TOPIC: PC-23-07 - Peninsula Site Plan Review

BACKGROUND BRIEF: The Peninsula is a site plan request for a 3-unit, single-family, site condominium development located at 160 Darling Drive, Parcel #: 09-02-458-015 - just south of Lake Street and west of S. Park Boulevard. The Project scope includes:

Peninsula Condominiums Site Plan Review

Please see the attached revised site plan documents addressing the review comments from Nowak and Fraus's review letter dated December 14, 2023, Orion Township Fire Department review letter dated December 18, 2023, and Mckenna review letter dated December 19, 2023 (responses are *italicized*):

SITE PLAN
PENINSULA OF LAKE ORION

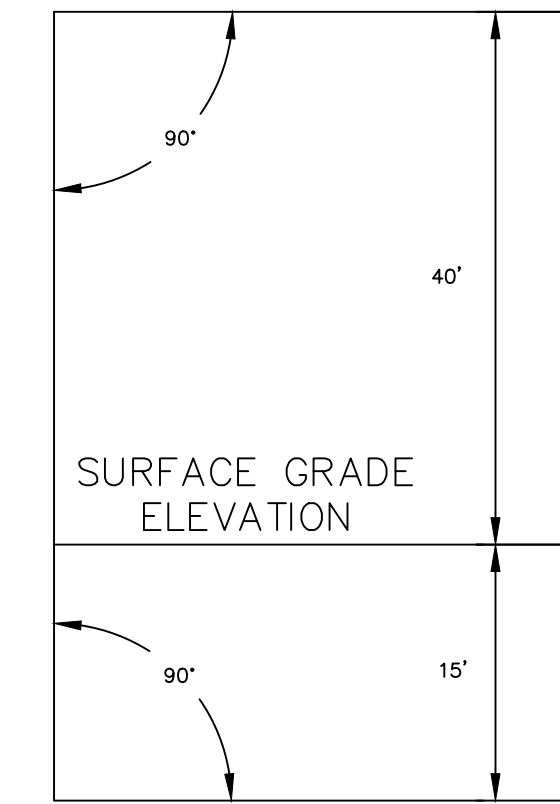
1. The Master Deed has been revised to address our previous review comments.
2. We note sheet 4 of 4 still includes “The” in the project name. Final condominium plans must show a consistent project name.
3. Applicant has acknowledged that a LOMR-F is required to reflect the proposed revised floodplain contour. This will be done after construction.

H:\2020\100\20107.30 The Starboard\Design\CAD\Peninsula Construction Docs\02 Topographic Survey.dwg

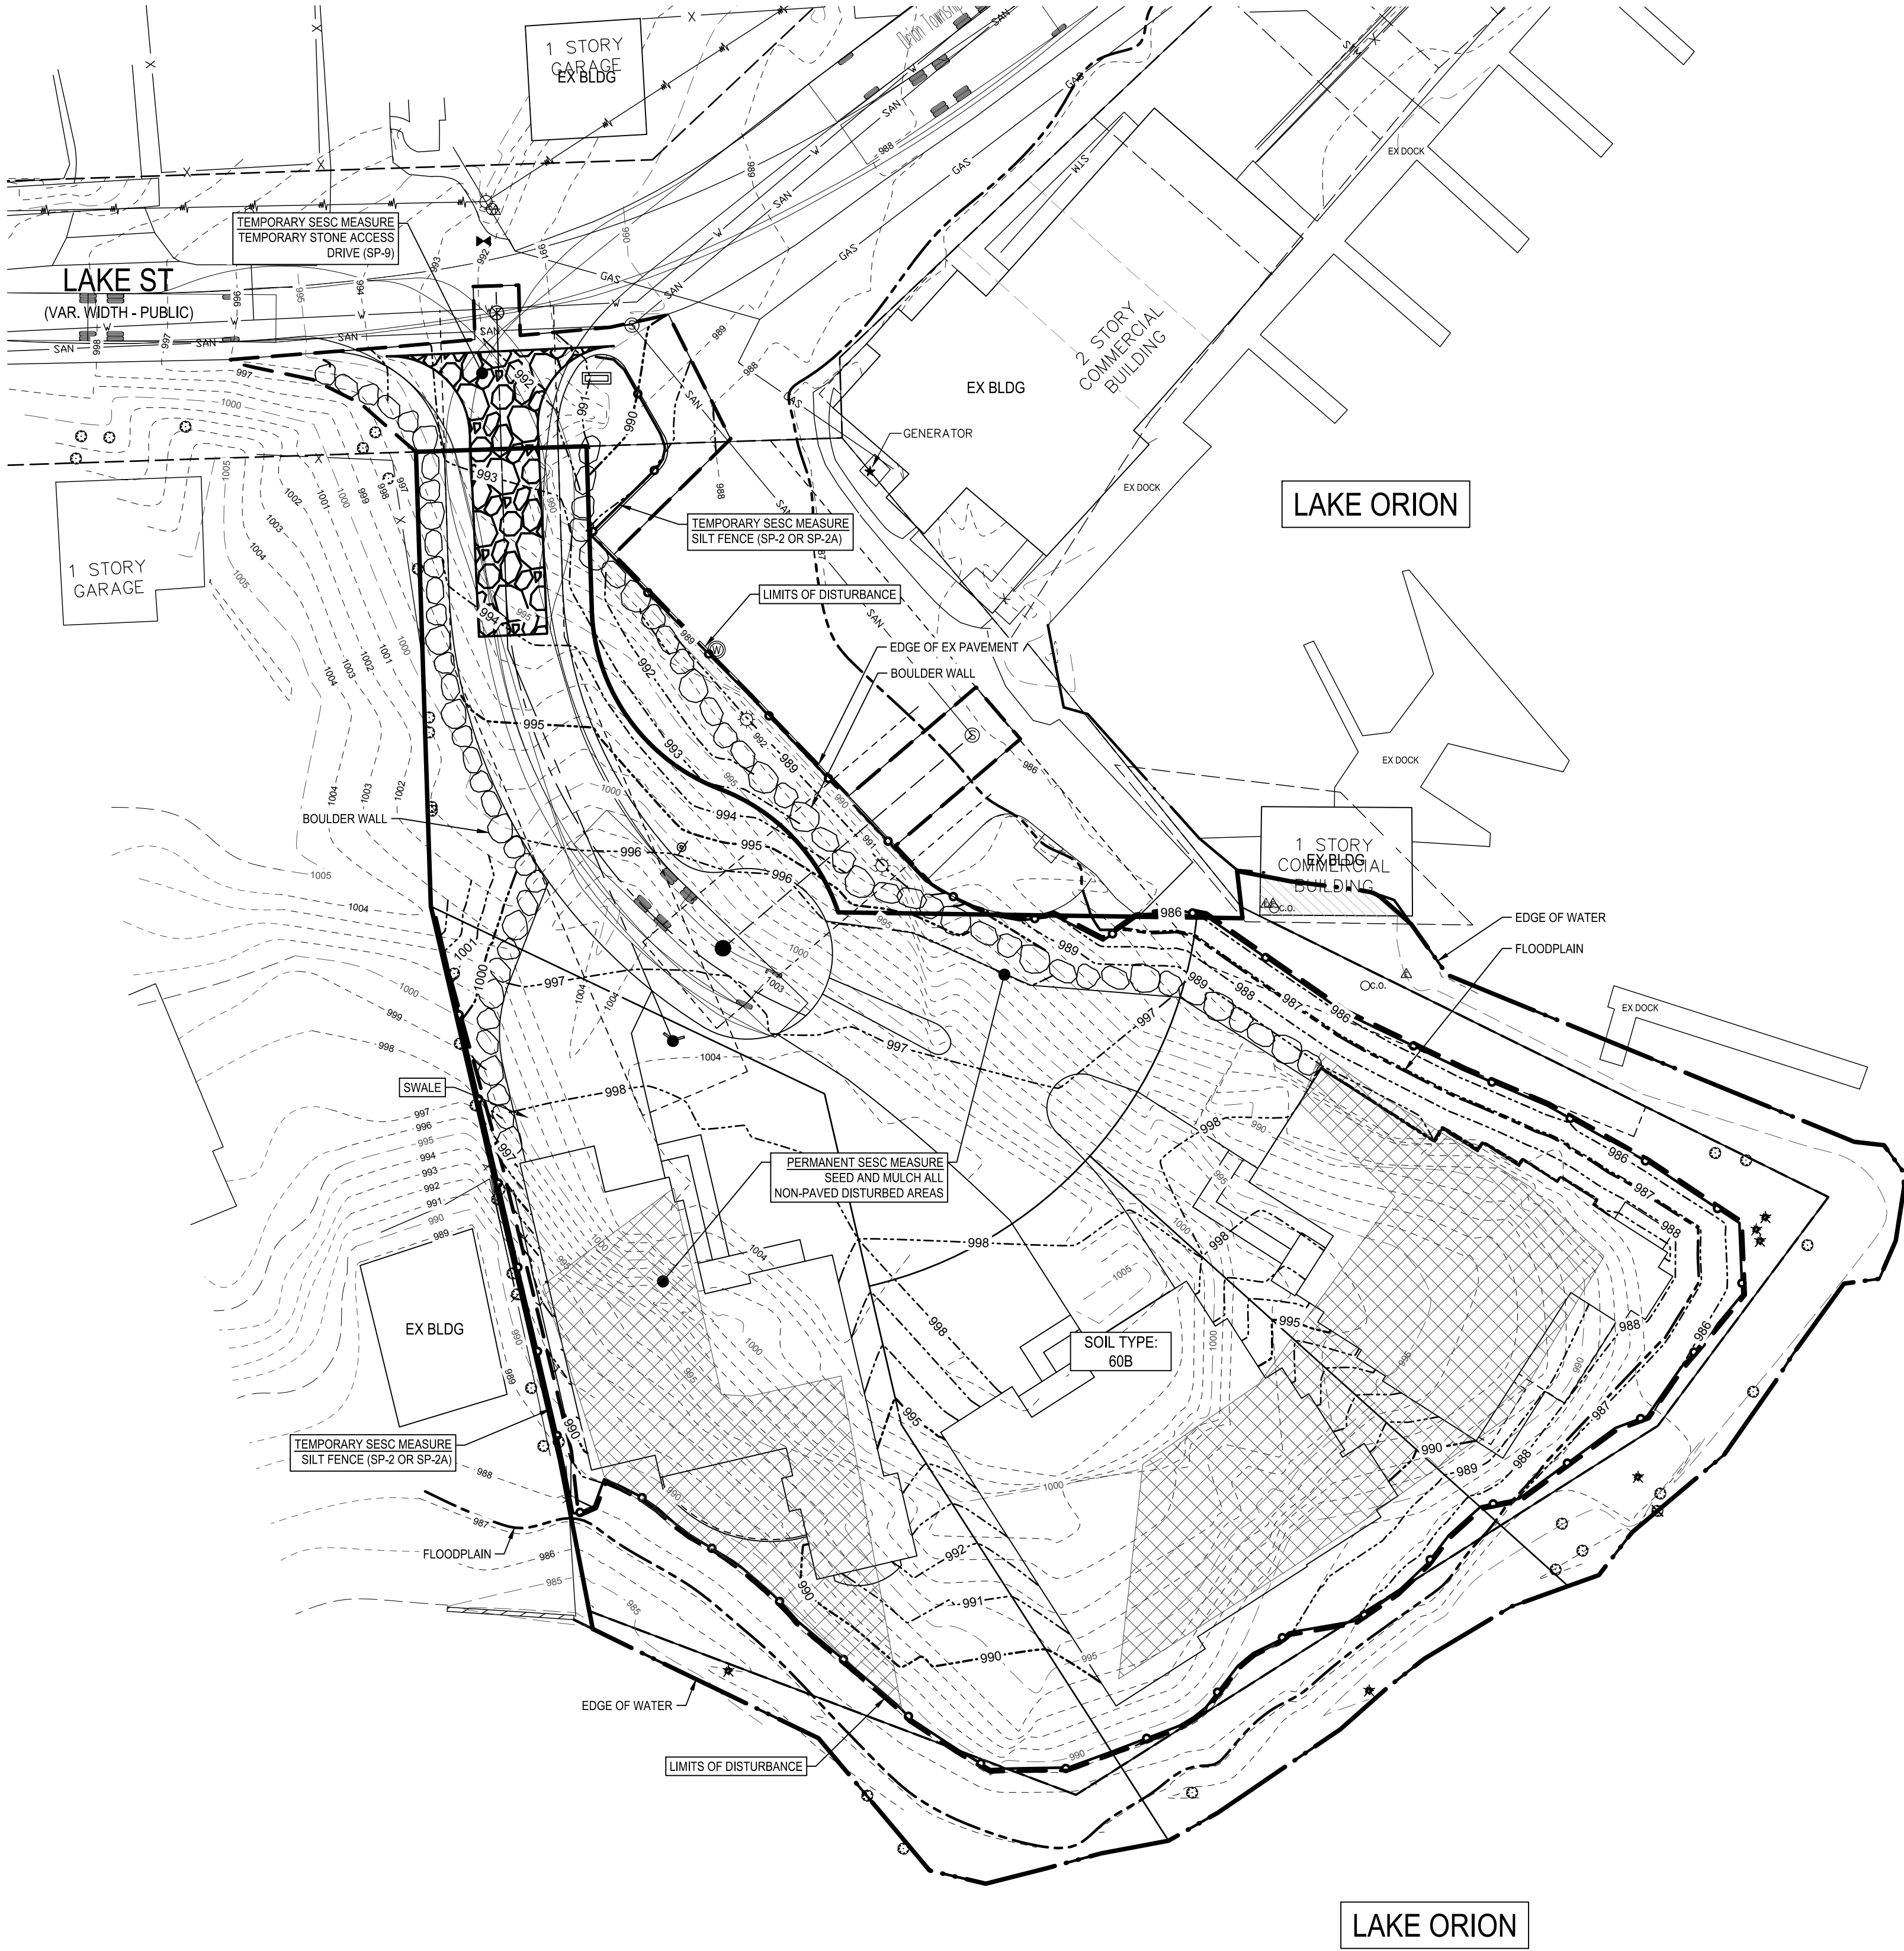
3. The site location map (see Sheet 2) places this project where the reconfigured Starboard development is proposed.
Located map has been deleted.
4. The graphic scale and written scale do not match on sheet 2. The graphic scale still reads 1" = 30', the actual scale is 1" = 20'.
Scale has been revised.

5. The graphic scale and written scale do not match on sheet 2.
6. Topography, including existing structures and their height, must be shown to 50’ outside the site boundary. It is shown to approximately 25’.

3. The site location map (see Sheet 2) places this project where the reconfigured Starboard development is proposed.
4. The graphic scale and written scale do not match on sheet 2. The graphic scale still reads 1" = 30', the actual scale is 1" = 20'.

Sheet 2 of the construction site plans have been updated.
6. Neither the Exhibit B cover sheet nor Article I of the Master Deed include the article "The" in the name of the condo project, while "The" is shown in the project name on all the other sheets of Exhibit B.
"The" is removed.

SITE & PAVING PLAN

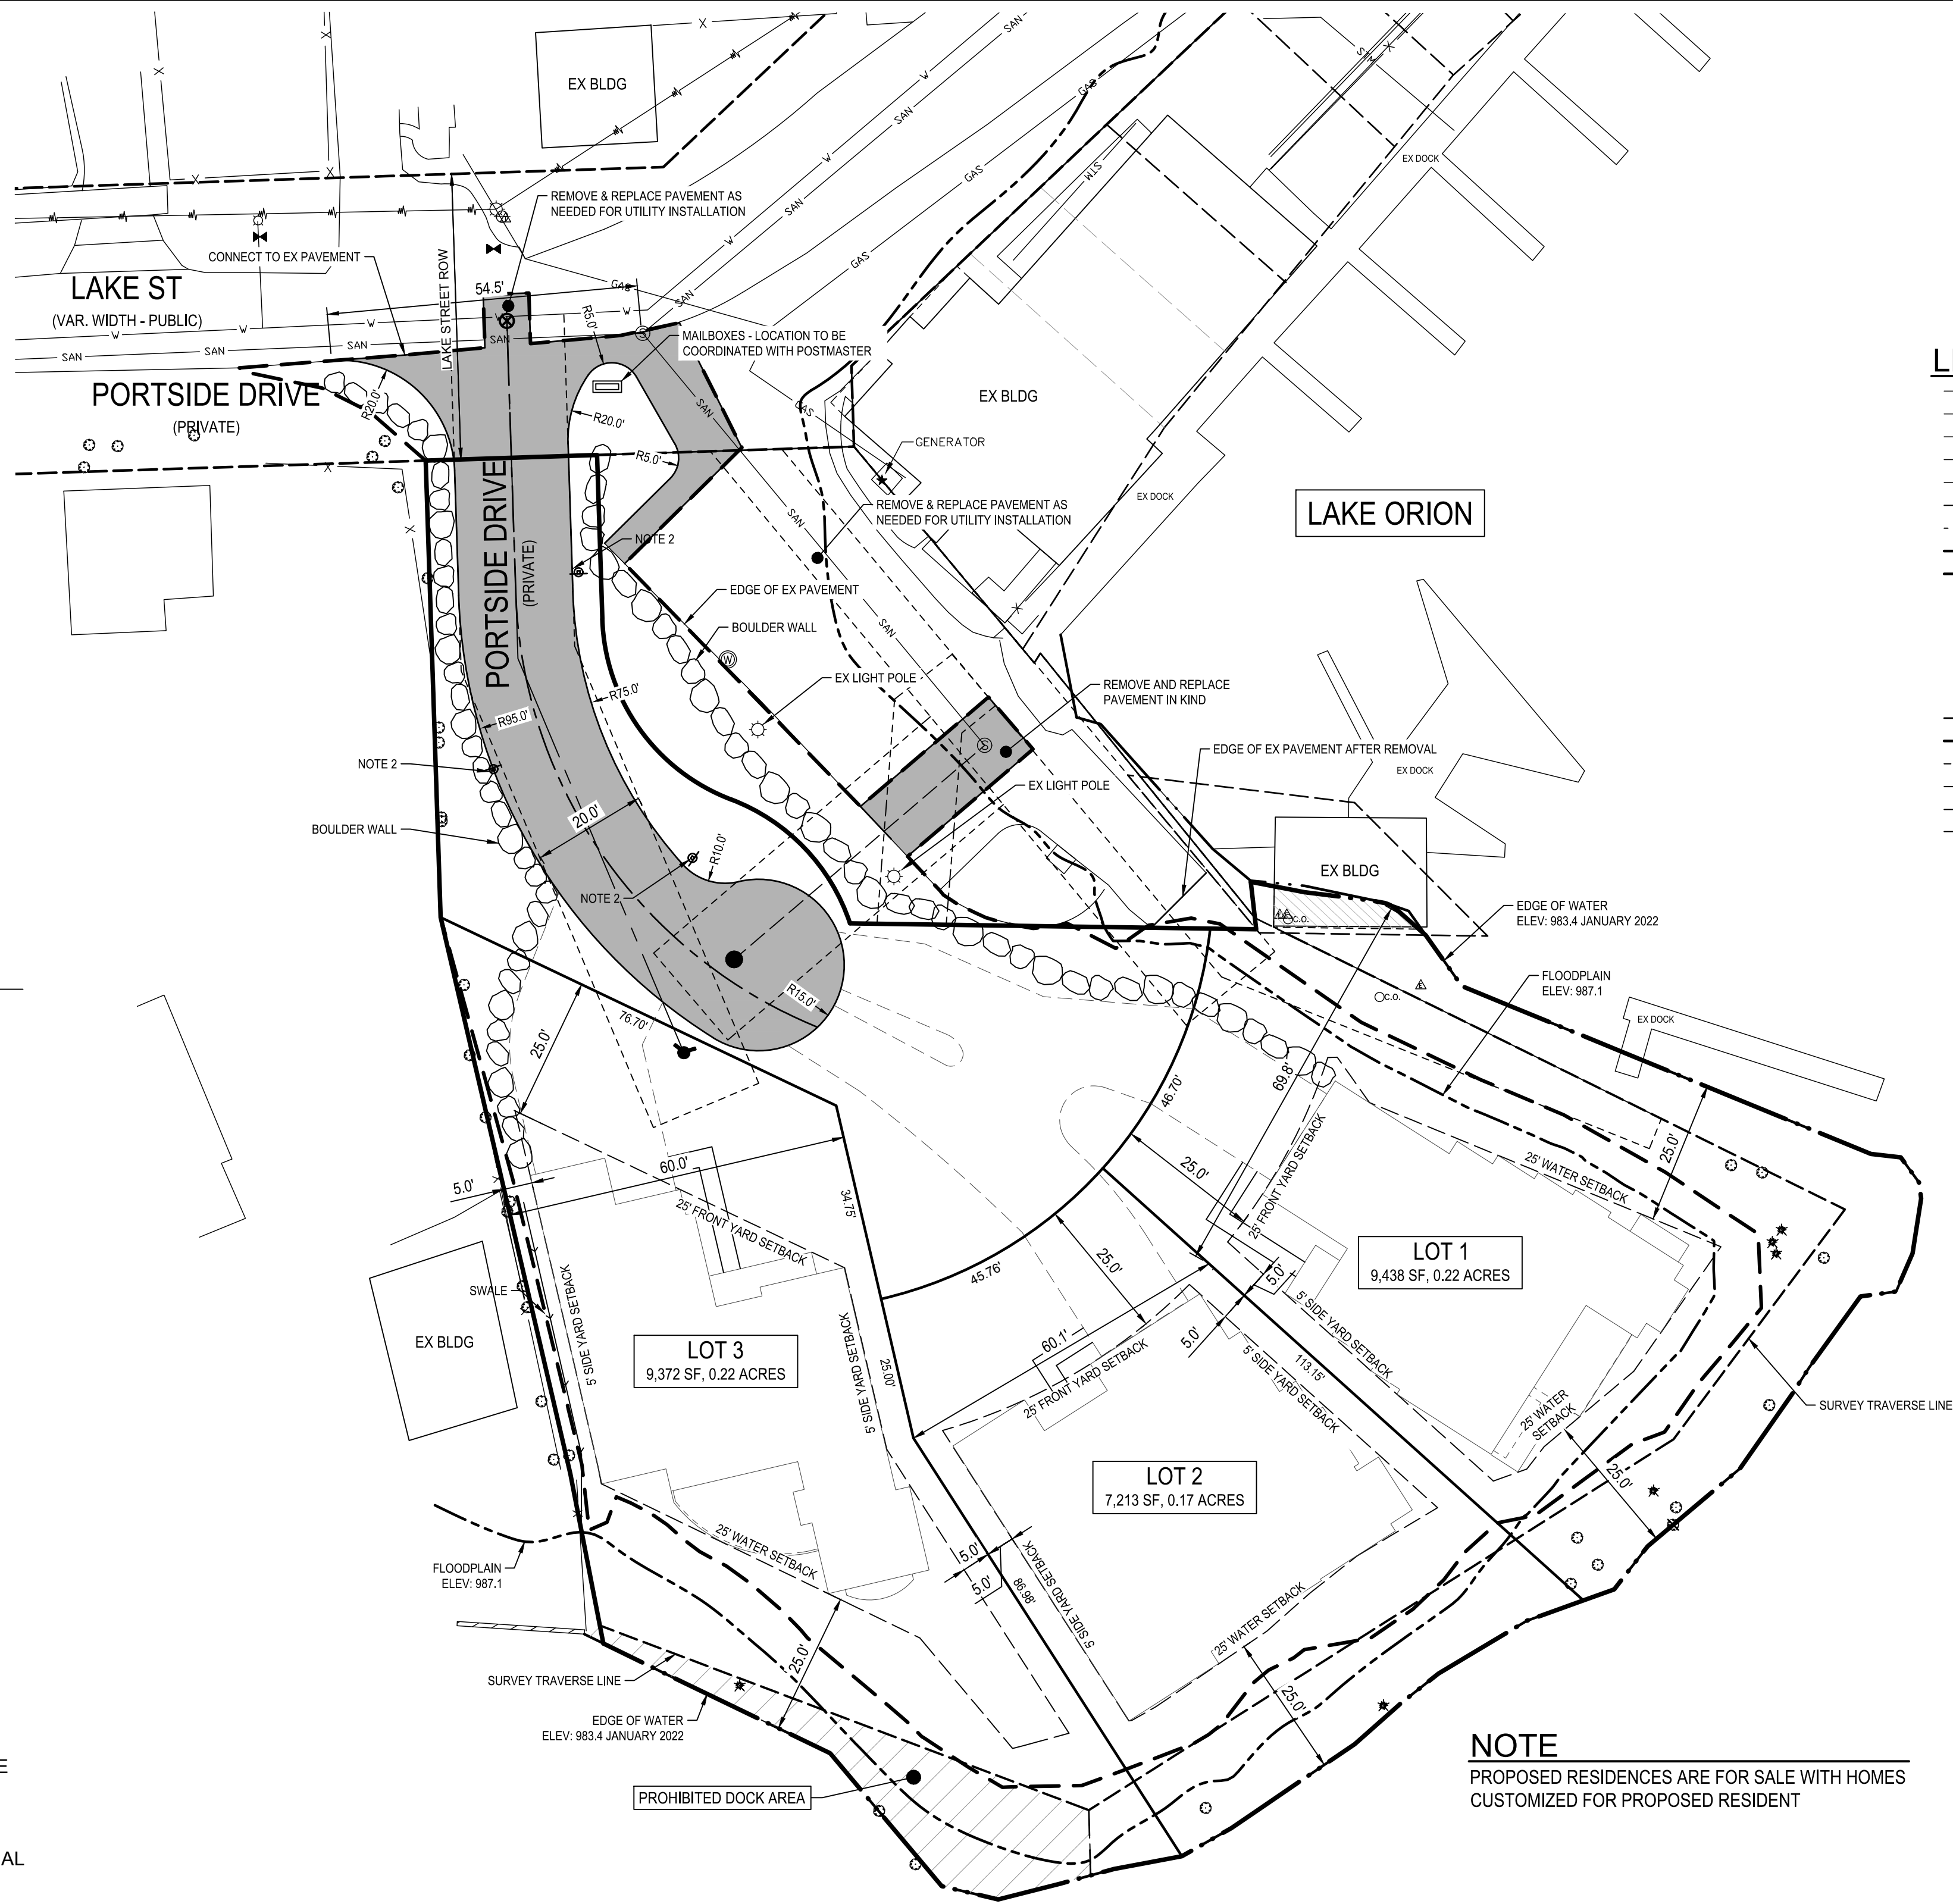
5. Response letter states that right of way lines for Lake Street are shown; however, they are not labeled on any sheet. Also, Sheet 4 shows Portside Drive labeled in both the proposed private road and the public Lake Street right-of-way.
The ROW was labeled on both the topo and the site plan. Portside Drive label has been deleted.

5. Response letter states that right of way lines for Lake Street are shown; however, they are not labeled on any sheet. Also, Sheet 4 shows Portside Drive labeled in both the proposed private road and the public Lake Street right-of-way.

3. As stated in our last review, remove the “Portside Drive” label from the Lake Street right-of-way on sheet 4.
4. Applicant has stated that trees are being saved where possible and has provided a tree chart for Planning Commissioners’ information.

Signs are shown on Sheet 4.
